SUBJECT: Oxygen Sensor Wiring Harness Voluntary Recall Campaign No. 98A02

MODEL: E36 with M42 engine (manual transmission only)

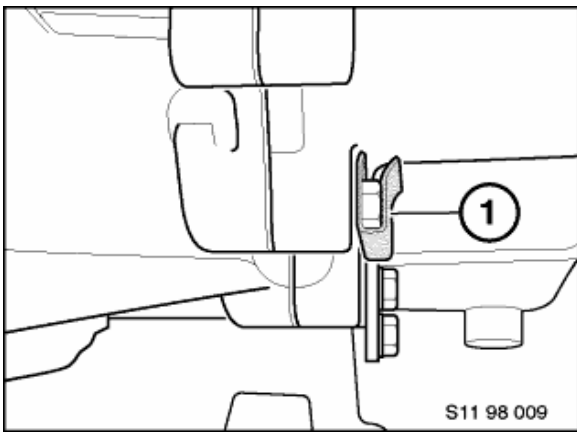
- Troubleshoot and repair DME fault codes other than fault code 70 using the DIS tester instructions as necessary. (Note: Other DME fault code repairs are covered under the terms of the BMW Emissions and New Car Limited Warranties.)
- Check the oxygen sensor harness for hold down clips or any signs (crimped or pinched areas in the sheathing) where a clip or other hold down device may have been installed in the past.
The illustration below shows possible areas where the harness may be fastened with clips: (1) clip on exhaust heat shield, (2) bracket on transmission.

- Remove all clips from the exhaust heat shield, transmission bracket and any other oxygen sensor wiring harness hold down devices (wire ties, etc.).
- If installed, bend the transmission bracket (1) using a pair of pliers up over the bolt head as shown in the illustration below.

Warning: Do not remove and install the bolt from the transmission housing to remove the bracket since this will lead to transmission oil leaks.

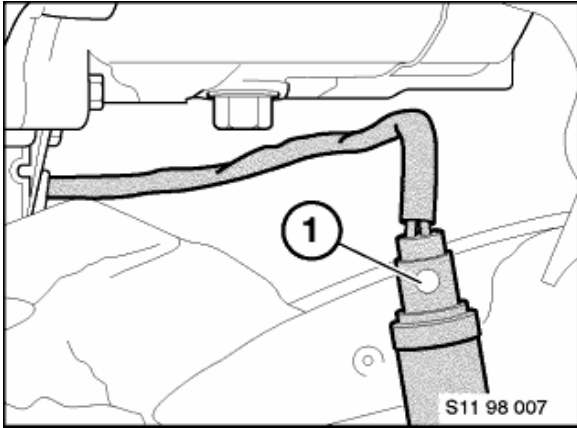
- fault code 70, (oxygen sensor disconnected) is stored in the DME.
Install the new oxygen sensor (1) if necessary, routing the wiring harness as shown in the illustration below. The harness should not contact any other components when routed correctly.
Do not use any hold down clips, wire ties, etc. to fasten the harness.
